TENTATIVE PARTITION PLAN  
FOR  
**BROOKE + DEVIN DVORAK**

SUBJECT: PA 24-01 - Engineering Comments

SUBJECT: PA-24-01 –4517 Waverly Dr NE - Residential Partition – Fire Department Comments

**NOTICE OF TENTATIVE DECISION**  
**PA 24-01 Dvorak Partition**  
**COMMENTS DUE March 7, 2024**

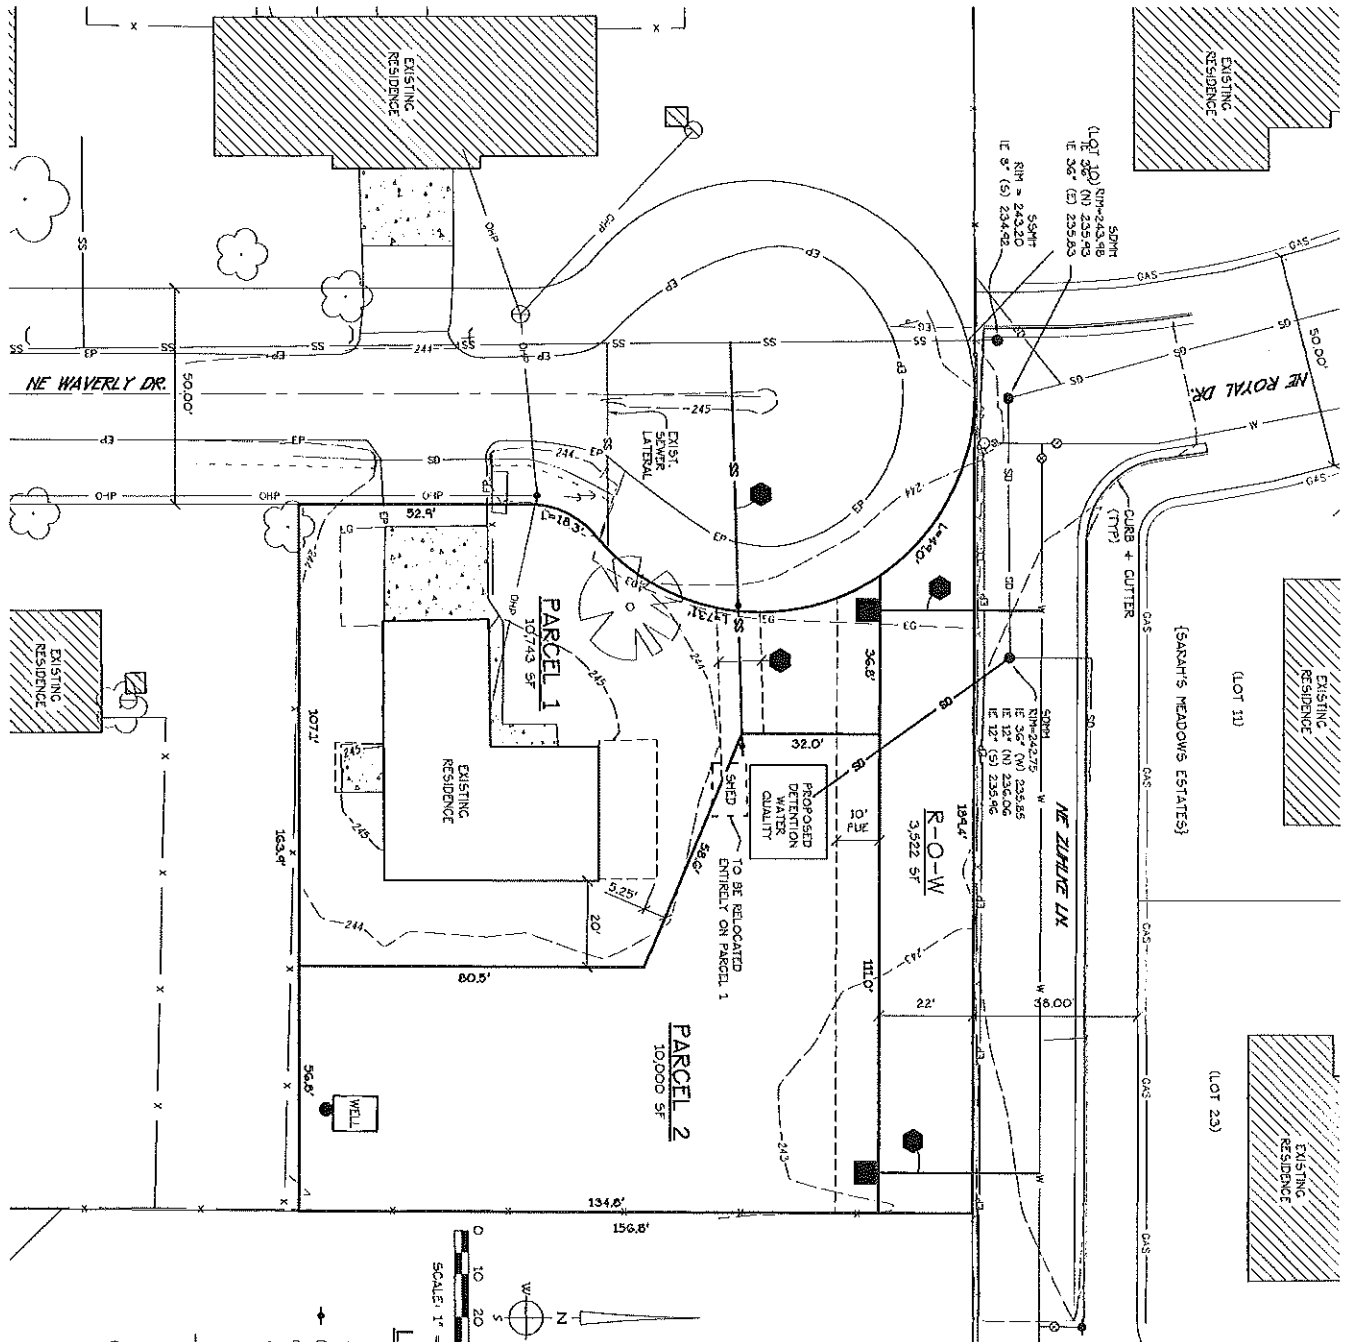
**ANALYSIS:** Proposed parcel 1 features a duplex and an accessory structure, which is labeled to be removed. A condition of approval has been added to require the removal of the accessory structure prior to the City signing the final plat.

There is also a small building covering a well that is currently in use on the property. Once the map is recorded the well will be on parcel 2. The well will be abandoned when the structure for parcel 1 is connected to City water as shown on the tentative map and explained in the narrative. This is consistent with the requirements of the Development Code. The well-house is not considered a structure because it is less than 200 square feet, however, setbacks still apply. The well-house will not meet setbacks for an accessory structure (which is 5 feet) and will need to be moved or removed. A condition of approval has been added.

The duplex also features a patio cover. This is shown encroaching into the setback on proposed parcel 1. At the time this was drafted there were no specific regulations regarding attached patio covers in the development code. As such, encroaching into the required setback is not specifically addressed and the attached patio cover is therefore not considered part of the structure for purposes of this application.

**ANALYSIS:** The project site features an existing duplex that is not currently connected to City water, but is connected to City sewer. Both parcels require water and sewer connections. The existing duplex on Parcel 1 will have to be fully connected to the City water system, and pay all water System Development Charges (SDCs) prior to City approval of the final plat. Conditions of approval reflect this. Water lines are available, now, directly north in NE Zuhlke Lane, which fronts the proposed parcel 2. Sewer lines with capacity exist in NE Waverly Drive. The map shows laterals for both on the plans.

**ANALYSIS:** The applicant provided some storm drainage details insofar as they showed a basin on parcel 2. However, a drainage plan will need to be submitted prior to the approval of the final plat.

- Prior to the City approval of the final plat, the shed and well-house shown on the tentative map shall be removed or relocated. Any new location must meet all setbacks and other zoning requirements.

- Prior to City approval of the final plat, the Applicant must provide a drainage plan for review and approval. All roof drains and yard drainage from Parcel 2 must be piped or trenched to an approved discharge point. If the drainage plan requires easements they must be recorded on the final plat. The drainage plan must meet all the requirements of the Millersburg Development Code Chapter 3.04, to the satisfaction of the City Engineer. The plan shall address stormwater quantity and quality requirements in accordance with the Millersburg Engineering Standards.
- Prior to City approval of the Final Plat, the applicant shall construct all required drainage facilities, or, at the discretion of the City, provide bonding (or similar) for all improvements approved by the City, unless otherwise approved by the City Engineer.
